TVA Heinemann Molded Case Circuit Breakers (MCCBs)

Power Board

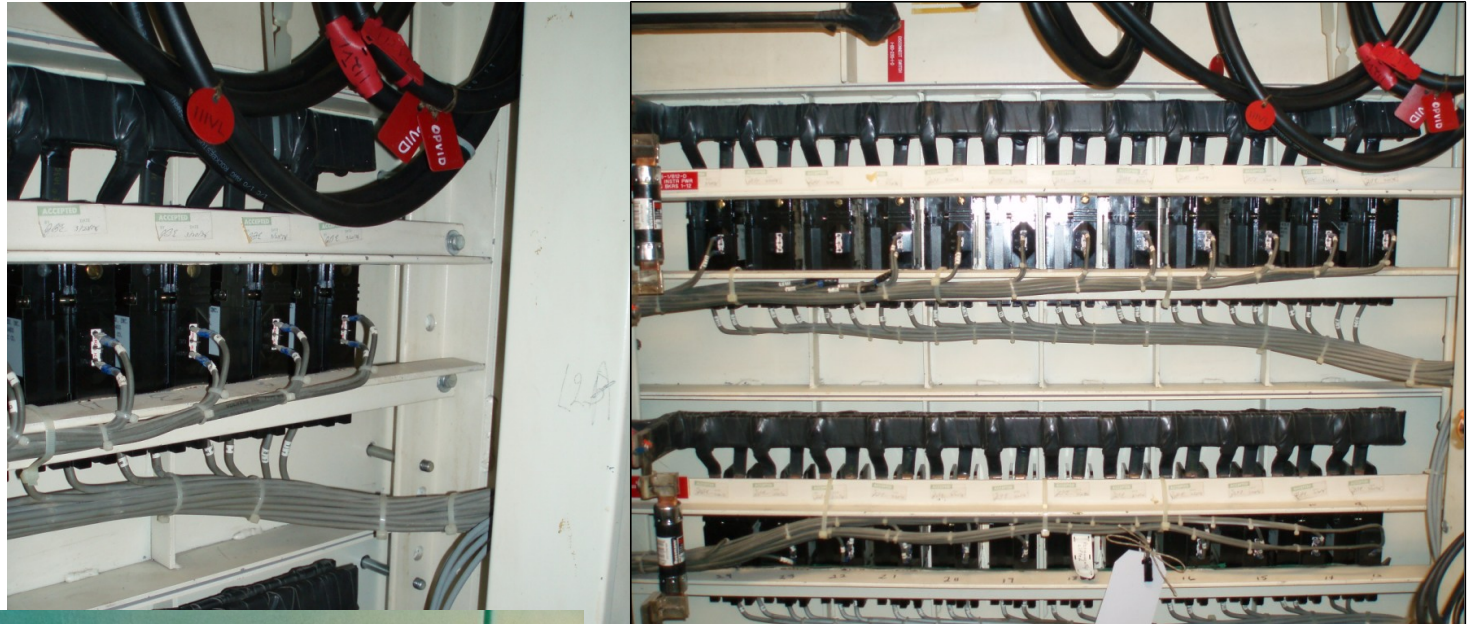
- The MCCBs mounted during testing are not representative of the breaker's clamped arrangement as installed in the plant.
- The test arrangement placed an accelerometer 13 inches below the upper-most row of breakers.
- The circuit breakers, as viewed on past inspections, did not appear to firmly fit into the panel.
- The licensee used spacer materials, not documented on design drawings, as installation aids.
